Panel Report

**Manningham Planning Scheme Amendment C104 and
Advisory Committee
Westfield Doncaster**

24 October 2018

Kathy Mitchell, Chair

Figure 3: Doncaster Road at Frederick Street – Additional storage for queued vehicles (highlighted by red oval)

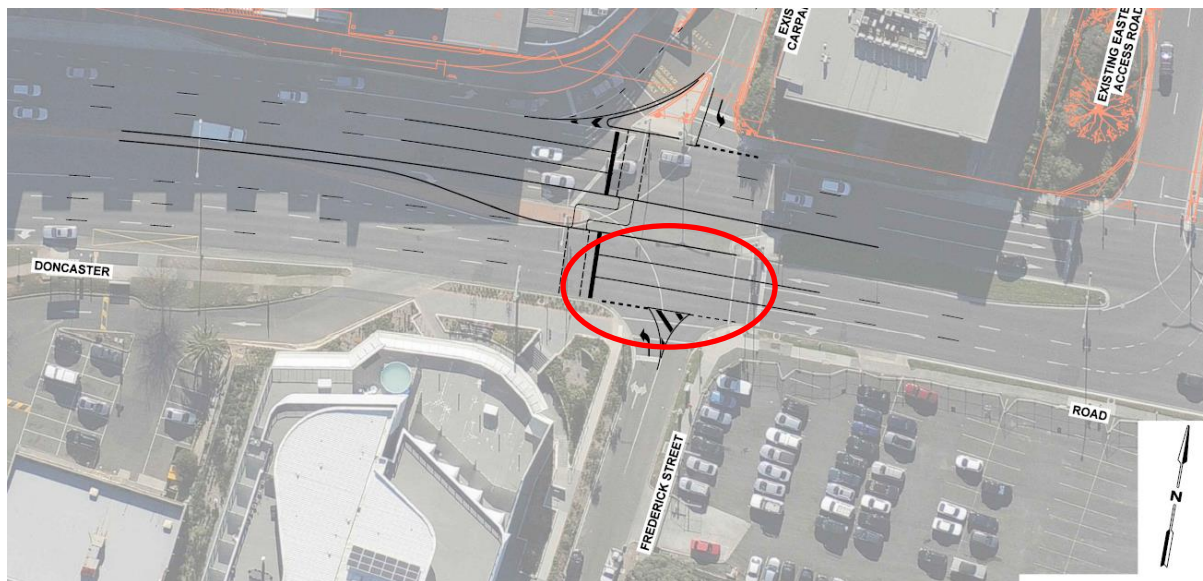
While the Williamsons Road/Doncaster Road/Tram Road intersection works would provide the primary benefit, Mr Kiriakidis advised that he could not provide a breakdown of how much benefit the proposed Frederick Street/Doncaster Road intersection works contributed to improved travel conditions along Doncaster Road. However, he noted that localised congestion was caused by vehicles exiting Westfield Doncaster, queueing from these signals back into the Centre. To alleviate this issue, additional storage capacity for queued vehicles was required and this could be achieved by shifting the proposed pedestrian operated signals further west from Frederick Street (Figure 3).

As discussed in Chapter 5, some residents and businesses expressed concern with the removal of right turns into and out of Frederick Street and consequently the need to perform U-turns upstream and downstream of this intersection. The Panel accepts that there would be capacity and time savings for Doncaster Road motorists with the proposed replacement of traffic signals with pedestrian operated signals at Frederick Street. The question is how much benefit derives from this part of the works. This does not appear to be known as in the modelling it is combined with benefits associated with the capacity upgrade works at Williamsons Road/Doncaster Road/Tram Road intersection. However, the Panel accepts that replacing the existing traffic signals with pedestrian operated signals west of Frederick Street provides additional storage for queueing vehicles. As such, it would provide benefit to road network operations.

Figure 4: Westfield Drive Entrance

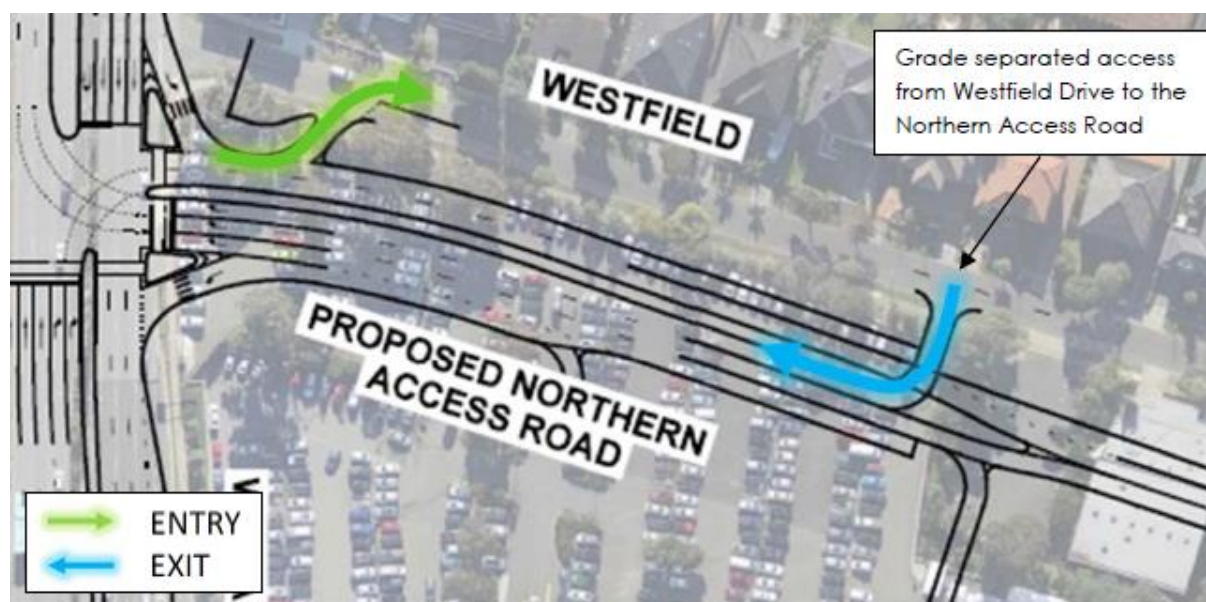
In relation to Westfield Drive, the majority of submissions (including S16, S20, S52 and S86) opposed the modified access arrangement as it would adversely impact residents due to:

The Westfield Drive proposed access arrangement separates the local from Westfield Doncaster traffic. Westfield Drive residents would now enter from a 'service road' opening in the Northern access road (refer to Figure 4).

To exit, Westfield Drive residents would utilise a dedicated road portal and associated traffic lane within the Northern access road approximately 90 metres east of Williamsons Road (refer to Figure 4). Local traffic wishing to turn left would need to merge across two lanes to access the left turn lane, which Mr Kiriakidis advised was sufficient distance for this 'weaving' manoeuvre to occur. He noted that Westfield Drive motorists would be physically unable to enter or exit the Centre's car parking facilities. This ensures vehicular traffic cannot access the Centre via Westfield Drive thereby reducing its attractiveness to non-local traffic.
